# NEW YORK STATE DEPARTMENT OF ENVIRONMENTAL CONSERVATION

Division of Water, Bureau of Water Compliance

October 23, 2024

## **NYSDEC Scenario 1 Issues (Solar Memo):**

## REVEGETATED GRAVEL ROAD SCARIFICATION DETAIL FOR UPLAND ROADS AND WORK AREAS

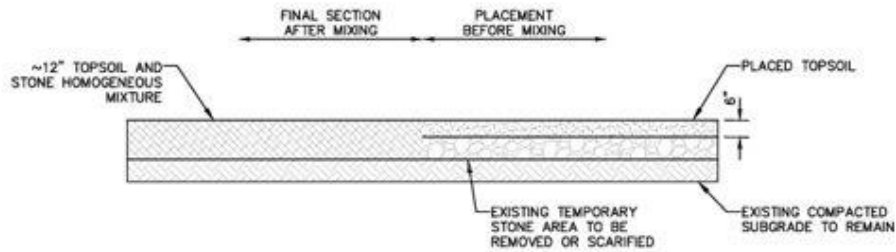
7. NYSEIA Question:

Does DEC require pervious access roads into the solar facility? If so, is there a typical you can provide for developers to reference?

One alternative that has been accepted on other sites is the revegetated gravel road scarification detail for upland roads and work areas. This can be used in areas that are not wetlands and are not agricultural areas where restoration is required. This road is meant for minimal intermittent use and does not have the load-bearing capacity to serve as emergency access for the site.
